Access Compliance Report

Public Rights-of-Way

(Island Curb Cuts)

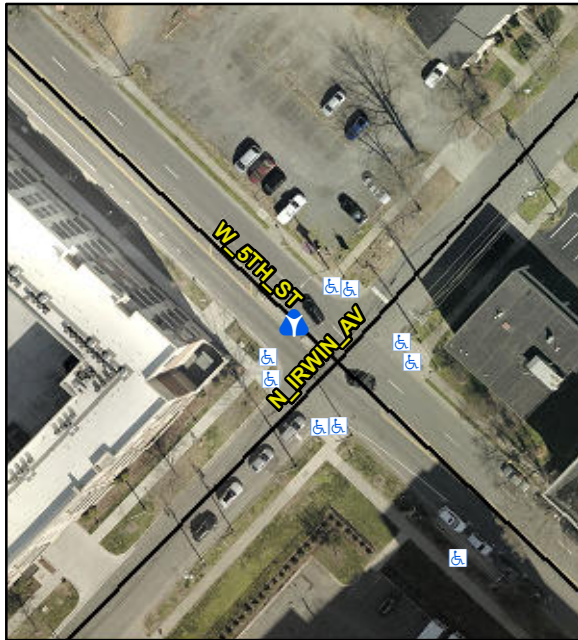
Intersection ID: 11256	Main Street: N_IRWIN_AV	Cross Street: W_5TH_ST	Location: W
ADA ID: A1379A94029C	Curb Cut Type: MedianRefuge2	Initial Pass/Fail: Fail	Overall Compliance: No
Severity Score: 1.25			
Codes/Mitigation Info/Possible Solution		Field Measurements/Component Compliance

Remove & Replace Entire Refuge.
